LORSON RANCH COMMERCIAL NORTH

EL PASO COUNTY TRAFFIC SIGNAL & SIGNING PLAN PCD FILE NUMBER SF248

CARRIAGE MEADOWS DRIVE /FONTAINE BOULEVARD
TRAFFIC SIGNAL & SIGNING PLAN

SIGNAL POLE & CONDUIT PLAN

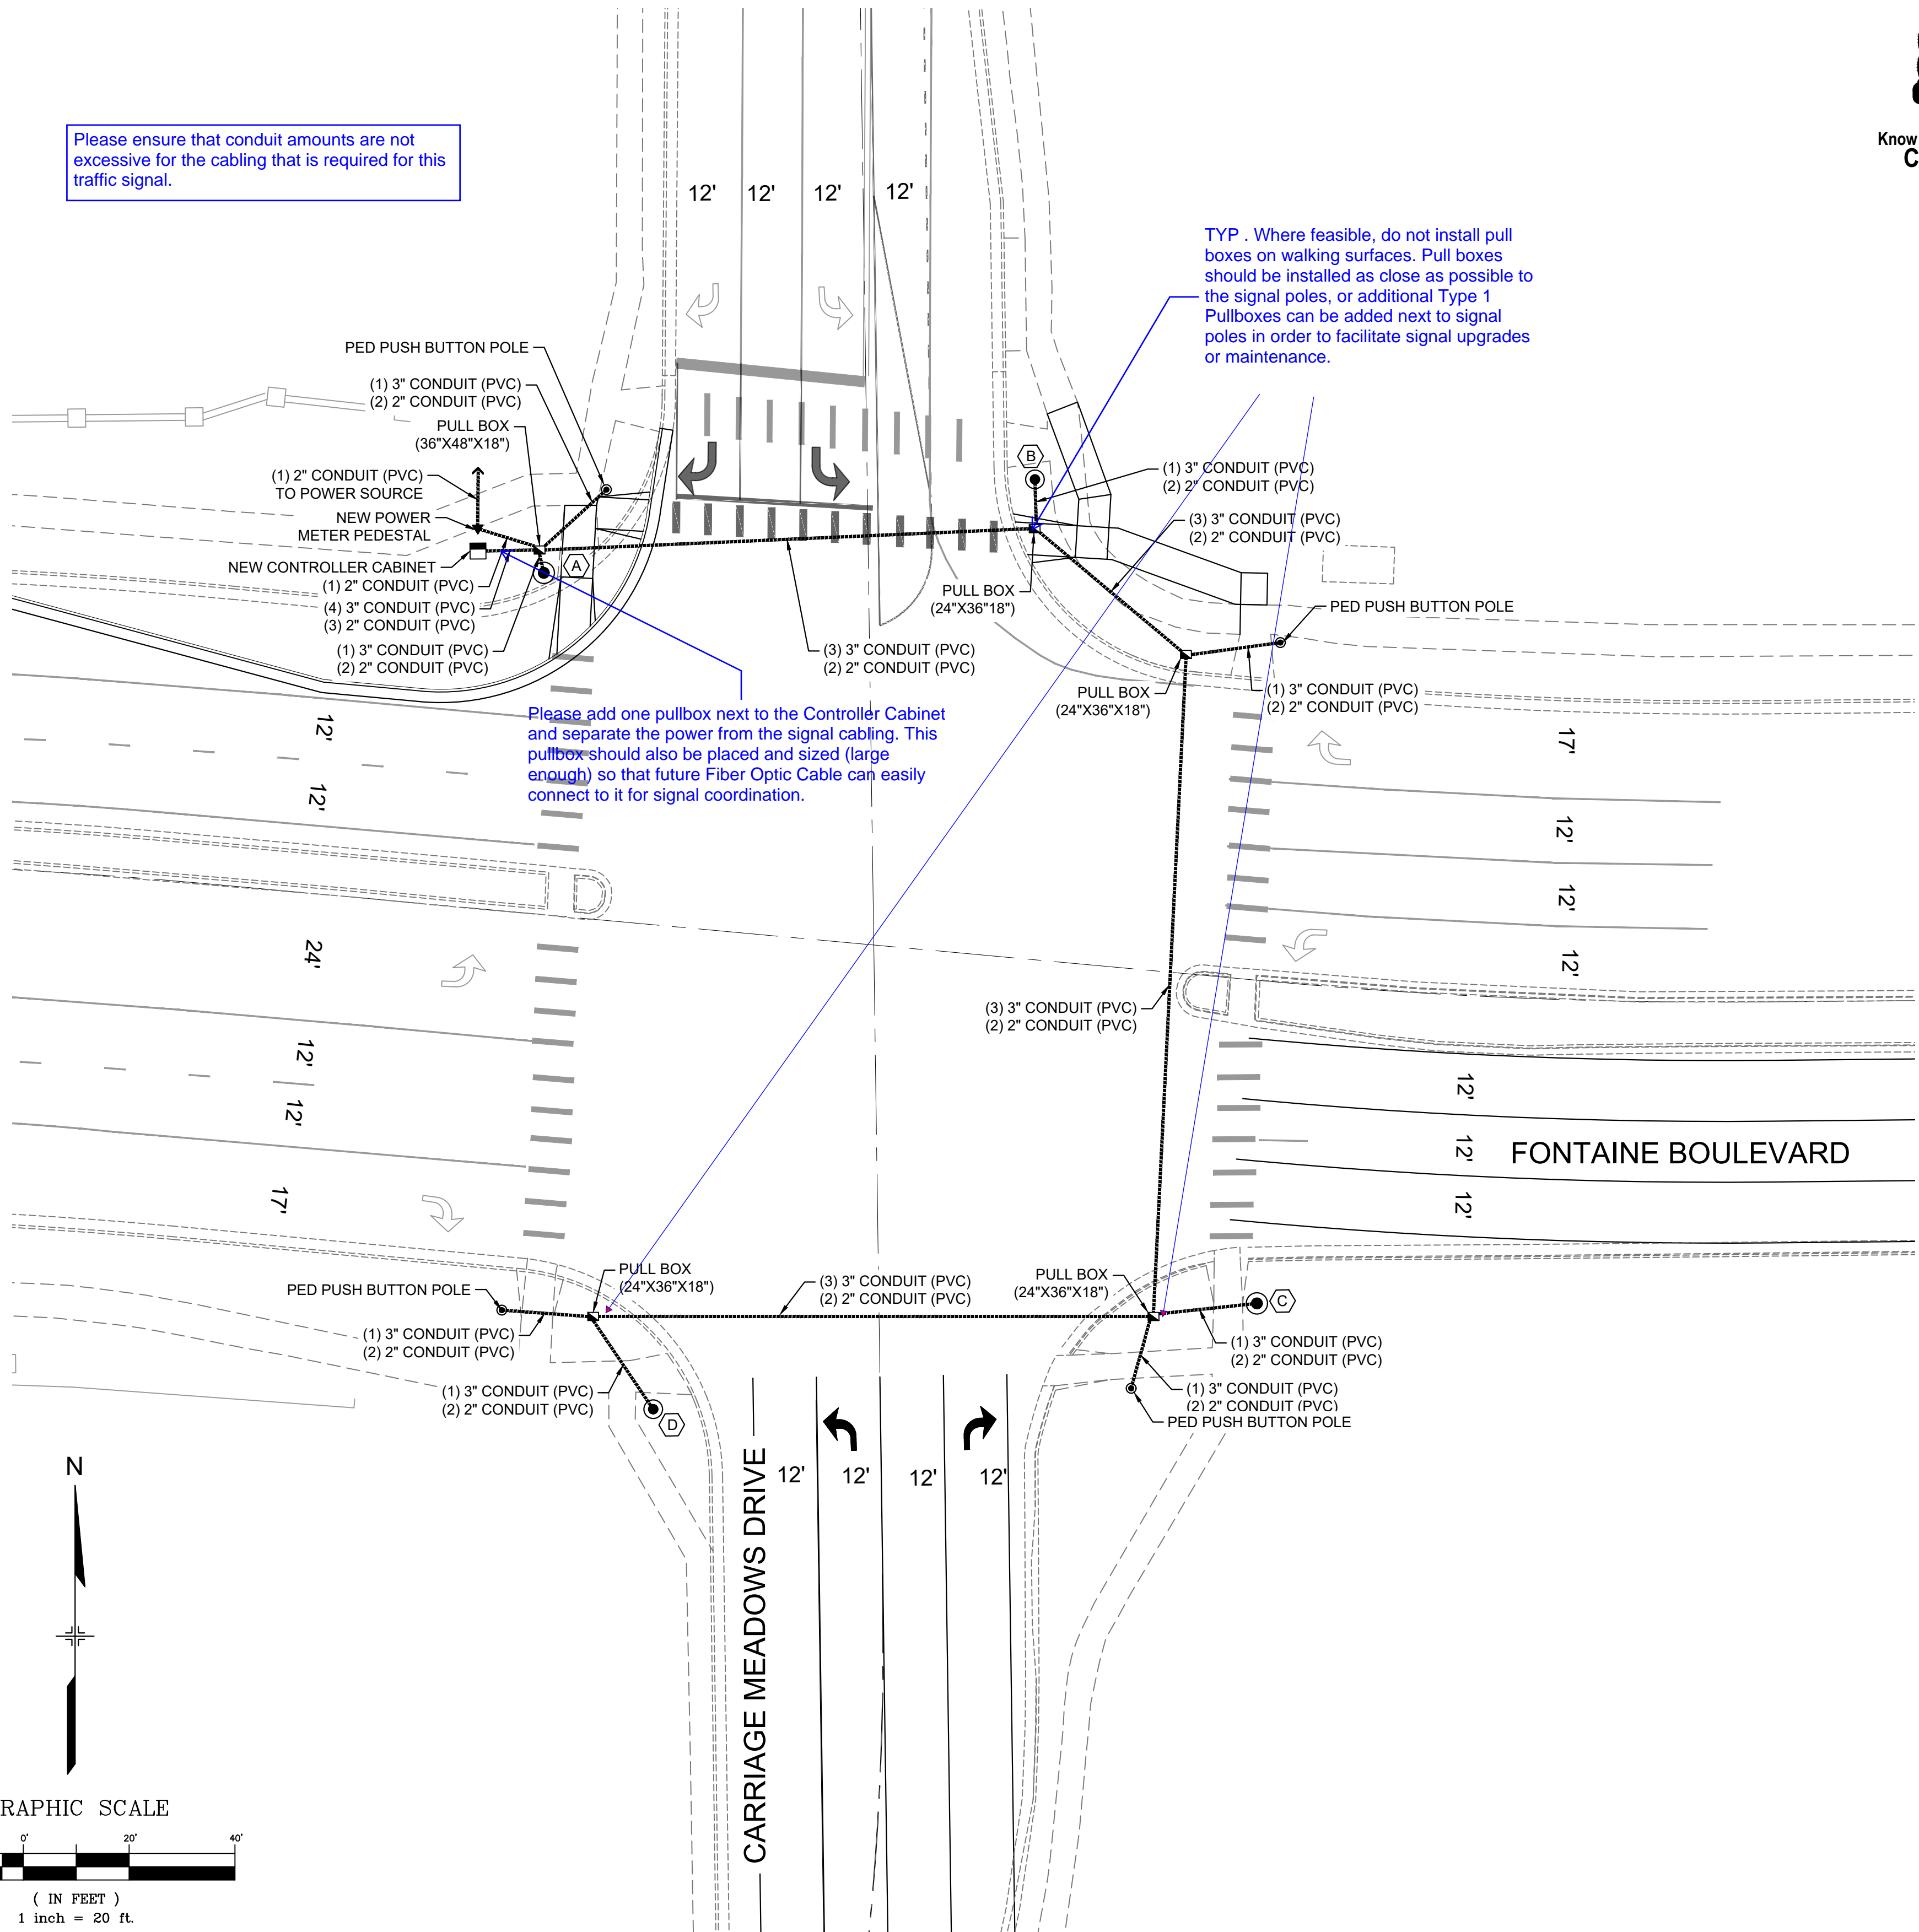
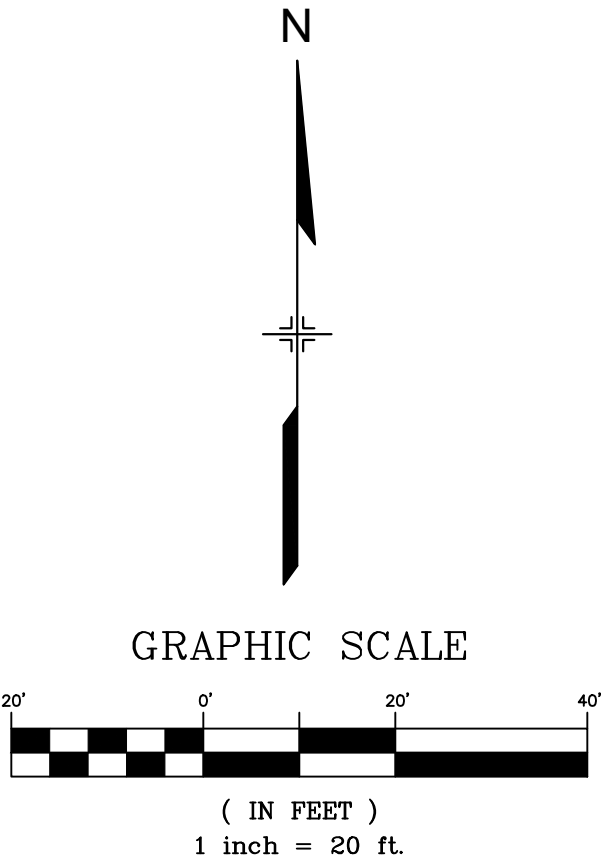
Please ensure that conduit amounts are not excessive for the cabling that is required for this traffic signal.

Please add one pullbox next to the Controller Cabinet and separate the power from the signal cabling. This pullbox should also be placed and sized (large enough) so that future Fiber Optic Cable can easily connect to it for signal coordination.

TYP . Where feasible, do not install pull boxes on walking surfaces. Pull boxes should be installed as close as possible to the signal poles, or additional Type 1 Pullboxes can be added next to signal poles in order to facilitate signal upgrades or maintenance.
